# Economic and Social Council

#### Group of Experts on Road Signs and Signals

##### Review of recommendations on A through F signs

## Proposal for amendments to Annex 1 and 3

**FALLING ROCKS**

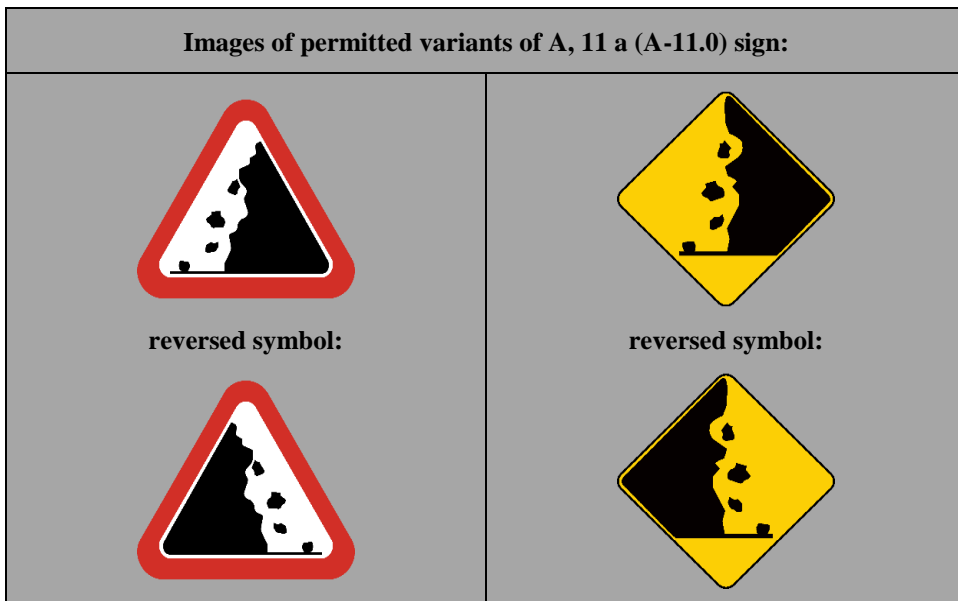
~~(a) Warning of a section of road on which there is danger from falling rocks and the consequent presence of rocks on the carriageway shall be given by symbol A, 11a used with the sign of model Aa or by symbol A, 11b with the sign of model Ab.~~

~~(b) The right hand part of the symbol shall occupy the right hand corner of the sign panel in both cases.~~

~~(c) The symbol may be reversed.~~

**A, 11 a (A-11.0) gives warning of a section of road on which there is danger from falling rocks and the consequent presence of rocks on the carriageway. The symbol on this sign may be reversed.**

**DOMESTIC ANIMALS CROSSING**

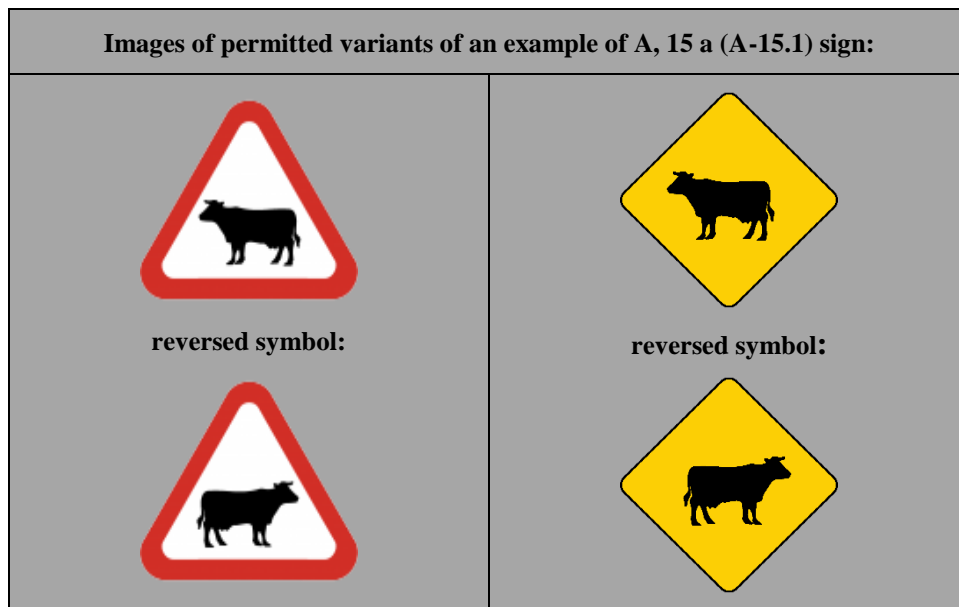
(a) ~~Warning of a section of road on which there is a particular danger of animals crossing shall be given by a symbol representing the silhouette of the animal, domestic or wild, most frequently encountered, such as symbol A, 15a for a domestic animal and symbol A, 15b for a wild animal.~~

(b) ~~The symbol may be reversed.~~

**A, 15 a (A-15.1) gives warning of a section of road on which there is a particular danger of domestic animals crossing. The symbol shall represent the silhouette of the domestic animal most frequently encountered. The symbol on this sign may be reversed.**

**ROUNDAABOUT**

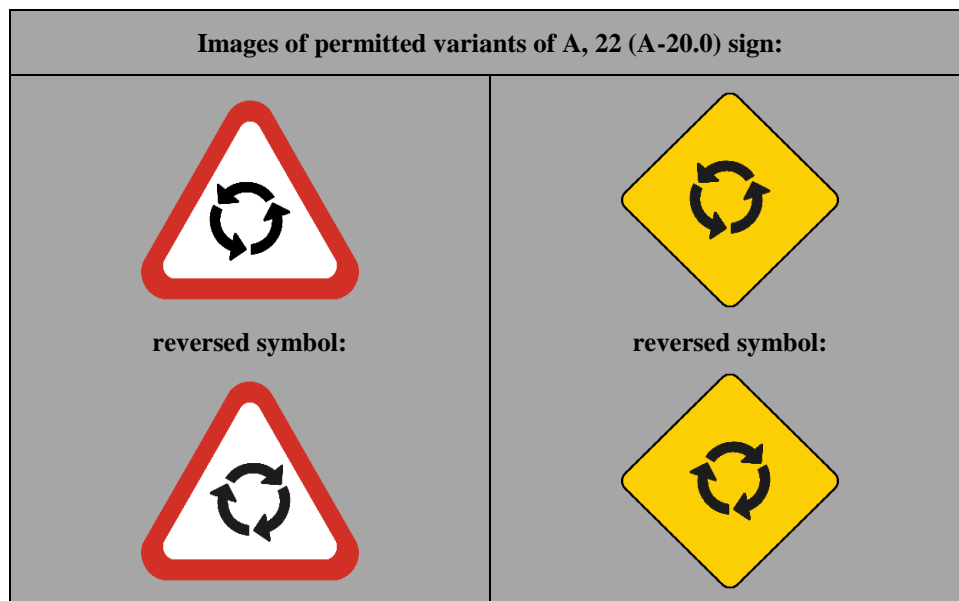
~~Warning of a roundabout shall be given by symbol A, 22.~~

**ROAD FOR MOTOR VEHICLES**

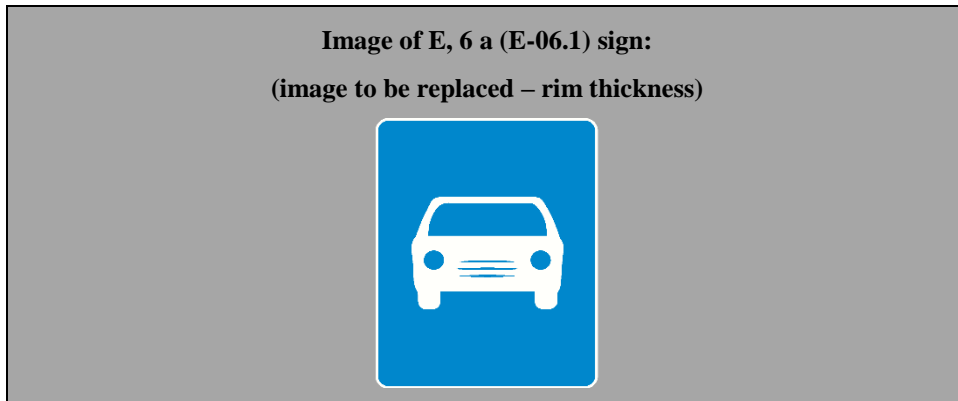
~~(a) Sign E, 6a (E-06.1), "ROAD FOR MOTOR VEHICLES", shall be placed at the point where special traffic rules, on roads other than motorways, begin to apply on roads other than motorways and which are reserved for motor vehicle traffic and do not serve properties bordering on the road. An additional panel may be placed under this sign E, 6a to show that, by way of exception, the access of motor vehicles to properties bordering on the road is permitted. This sign shall have blue or green ground, and a white symbol.~~

**PEDESTRIAN CROSSING**

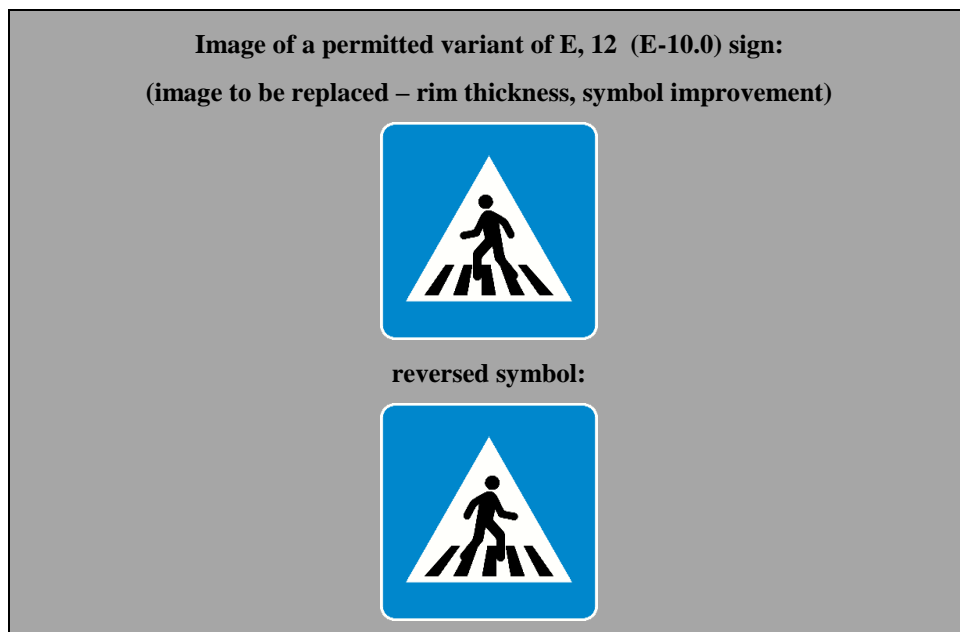
~~(a) Sign E, 12 (E-10.0) , "PEDESTRIAN CROSSING", notifies road users of is used to show pedestrians and drivers the position of a pedestrian crossing. The ground of the panel this sign shall be blue or black with the triangle a white or yellow triangle. and tThe symbol shall be black or dark blue.; the This symbol shall symbol displayed shall be a pedestrian on a crossing marked by broad stripes parallel to the axis of the carriageway. symbol as A, 12 a (A-12.1). The symbol on this sign may be reversed.~~

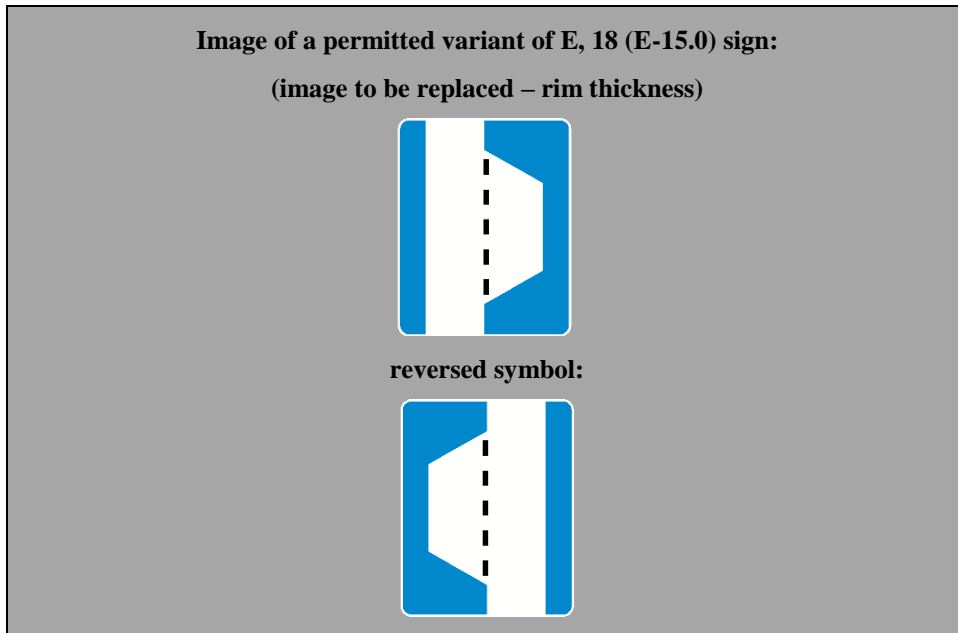
(image to be replaced – rim thickness, house symbol to be improved, thickness of parallel lines)
